• Changes from the ER-2385/2395

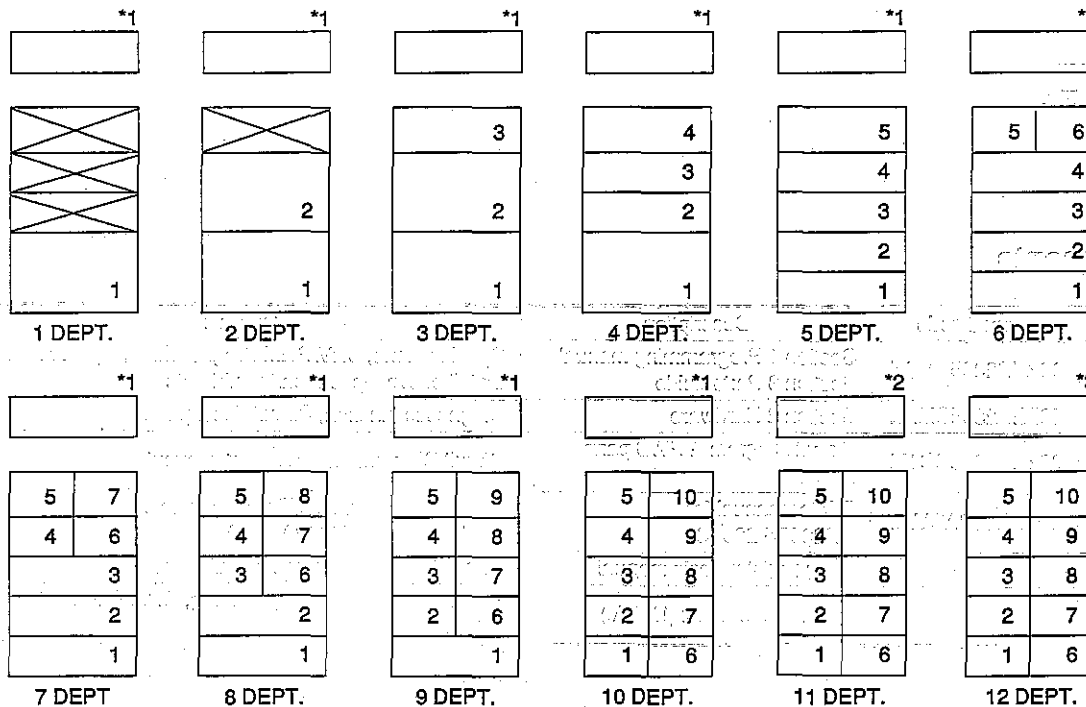
1. Change in the key layout

The number of DEPT's can be selected in the range of 0 ~ 12 by SRV-mode programming. The key layouts are as follows:

- : Dummy key
- 11 DEPT's and 12 DEPT's are for the ER-2395S only.

ER-2385S	ER-2395S
Key layout in *1	PLU TAX	%2
Key layout in *2	PLU TAX	11 %2
Key layout in *3	PLU TAX	11 12

- In addition, in the ER-2395S, [RA], [PO], [CONV] keys can be changed as follows to provide max. 15 DEPT's.

- [RA] → [DEPT. 13]
- [PO] → [DEPT. 14]
- [CONV] → [DEPT. 15] or [%2]
